Proposal for Supplement 16 to Regulation No. 38

This proposed amendment is submitted by the expert from INDIA, in order to amend the requirements for rear fog lamp, if it is grouped with stop lamp.

Examples for Rear Fog Lamp grouped with Stop Lamp

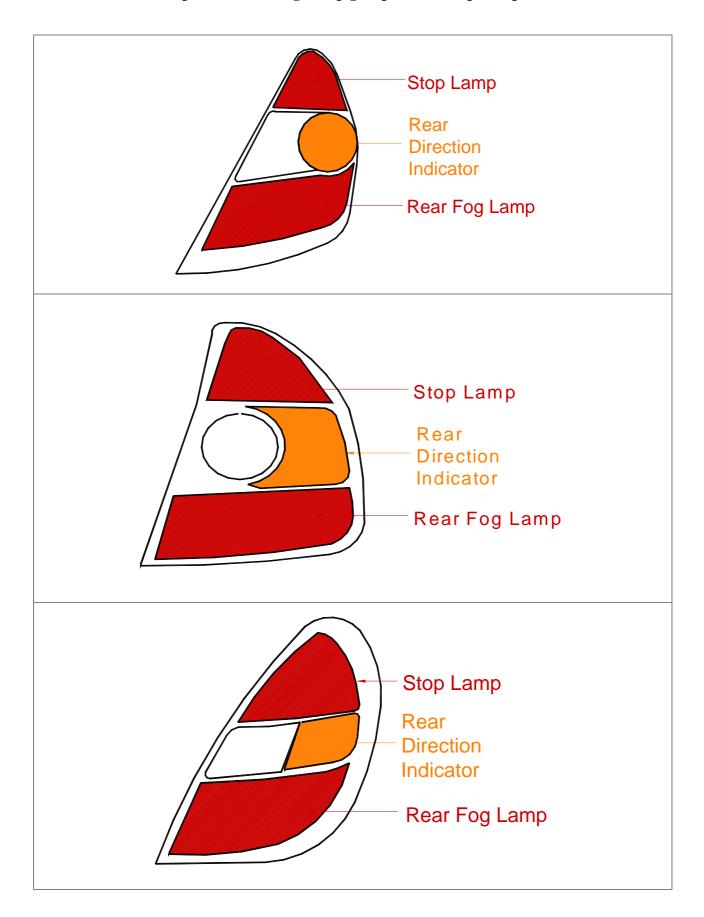
5.3 In case rear fog lamp is grouped with stop lamp, the distance between the rear fog lamp and each stop lamp must be greater than 100 mm.

- > There are designs being used today, where the rear fog lamp is grouped with the stop lamp. Some of such examples are shown in the attached pictures.
- > Considering today's design concept, generally, more complex and having close tolerances, it is very difficult to verify this requirement on the installation of devices.
- Verification of separation distance in such cases is much simpler to carry out on the device directly while approving the device for compliance to ECE R 38, rather than when mounted on a vehicle.
- ➤ The proposed amendment will avoid a re-verification during physical verification for compliance of the motor vehicle to ECE R 48.
